**Re: ABP case reference : PAX07.323699**

**Applicant : RWE Renewables Ireland Ltd**

Located within the townlands of Beagh, Beagh More, Cloonbar, Cloonweelaun, Cloonnaglasha, Cloonteen, Corillaun, Derrymore, Ironpool, Shancloon, Toberroe and Tonacooleen, Co. Galway

On reading the WEDG 2006 guidelines, referring to "wind take" on page 34, the recommended siting of turbines relative to each other are given. (different to siting relative to dwellings and adjacent windfarms / properties outside of the windfarm control).

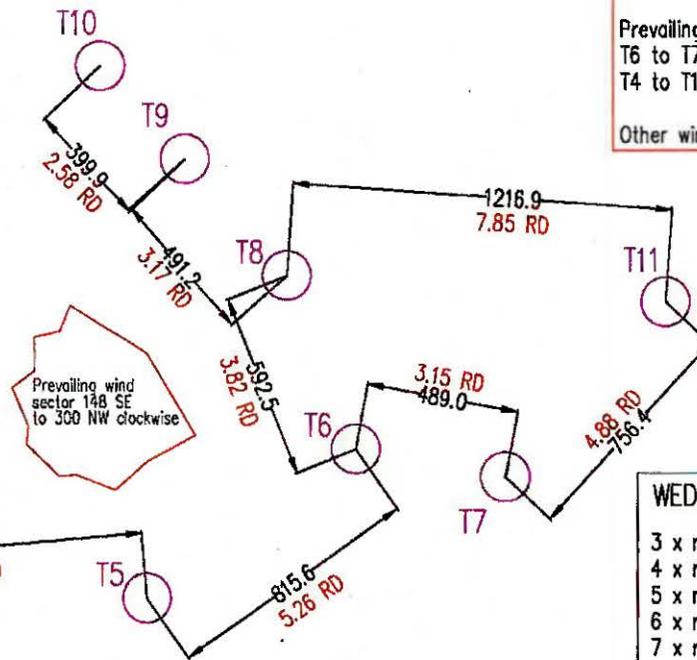
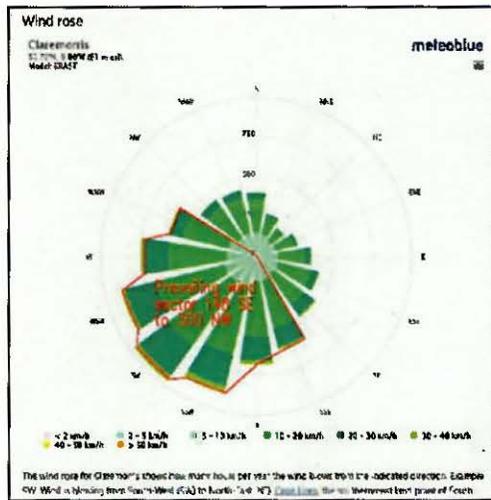
**It reads "In general, to ensure optimal performance and to account for turbulence and wake effects, the minimum distances between wind turbines will generally be three times the rotor diameter (=3d) in the crosswind direction and seven times the rotor diameter (=7d) in the prevailing downwind direction."**

Shanclon Windfarm layout  
 Horizontal separation distances between turbines  
 Map 1

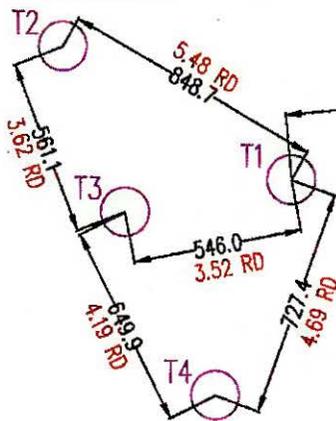
In ABP case reference **323699** to which this observation refers, the applicant has, as one can see in Map 1, next page, ignored the turbine separation distances from adjacent turbines, that are recommended in the WEDG2006 guidelines.

It should be noted that the prevailing winds, those requiring 7 rotor diameter separation distance between turbines, are not only from the southwest direction. Map 1 shows that in reality there are strong and frequent winds from 140 deg. Southeast to 300 deg. Northwest in a clockwise direction.

The following turbine spacing arrangements fail the required WEDG 2006 guidelines.

Prevailing wind Direction\_ T6 to T7, T6 to T8, T7 to T11, T5 to T6, T4 to T1, T2 to T1 and T3 to T1.  
Cross wind directions\_ T10 to T9.

Failed sets of turbine pairings per WEDG 2006

Prevailing wind direction:  
 T6 to T7, T6 to T8, T7 to T11, T5 to T6,  
 T4 to T1, T2 to T1, T3 to T1.

Other wind directions: T10 to T9.

WEDG 2006 says 7 rotor dia (RD) in prevailing wind and 3 rotor dia. in crosswind between turbines.

Therefore at least some turbines must be 952m (7.00 RD) apart at a minimum in the prevailing wind direction.

No turbine shall be within 465m (3.00 RD) of another turbine..

On the basis of what I have outlined and experienced, I highly recommend the aforementioned issues be carefully considered, and the design be altered significantly.
